UNE Wright College SSDA - Response to Submissions

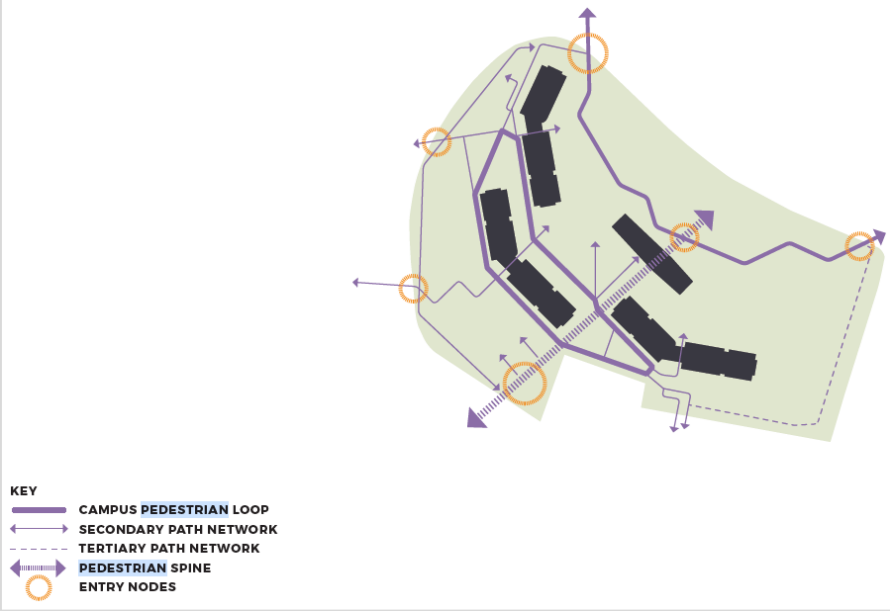
Comments from NSW Rural Fire Service	
Site to be managed (regarding landscaping) as an Inner Protection Area	This would be accepted by the applicant as a condition of any consent.
Abbott Road upgraded to 2 way, with fire hydrants to Australian Standards	Existing hydrants are currently installed along Abbott Road with an average spacing of 45m. It is unknown, at this stage, if they meet the minimum flow and pressure requirement of AS2419.1 (10L/sec @ 150 kPa). A new water main is proposed for installation under Abbott Road, with allowance for the installation of in-ground street hydrants. The location of hydrants is yet to be confirmed, however they will be provided at minimum 90 metre intervals to comply with the requirements of AS2419.1-2005 and AS2419.1-2018. The proposed hydrants will meet minimum flow and pressure requirements of AS 2419.1.

Item	Response
	Alternatively, the applicant will accept a condition requiring that the fire hydrants in question achieve compliance with the relevant Australian Standards.
Comments from Armidale Regional Council (ARC)	
Traffic impact assessment to confirm whether on street parking (i.e. Handel St) has been considered. Council has ongoing issues with Handel St.	The correspondence by TTW at Appendix 1 addresses this matter in detail. In summary, however, the Transport and Accessibility Impact Assessment (TAIA) accompanying the SSDA accounts for all parking impacts. The proposed parking exceeds Council's Development Control Plan (DCP) requirements for 'student colleges/ halls of residence'. The proposal provides a net increase of 194 spaces compared to existing. Council's parking requirements for 'student colleges / halls of residence' are as follows: ▪ 1 space per 2 students; ▪ 1 per resident staff; and, ▪ 1 per 2 full time equivalent non-resident staff. As the proposal accommodates a maximum of 342 students and seven (7) non-resident staff, the proposal would require 175 onsite parking spaces. The supply of 188 additional onsite parking space will address the DCP's parking requirements. Therefore, traffic and parking impacts to the wider road network are anticipated to be minimal. Handel Street is also located approximately 500m away from the site and any parking impacts on this street are also likely to be associated with the University as a whole rather than the Wright College proposal in particular. Council may wish to consider implementing additional parking restrictions to Handel Street to mitigate parking impacts.
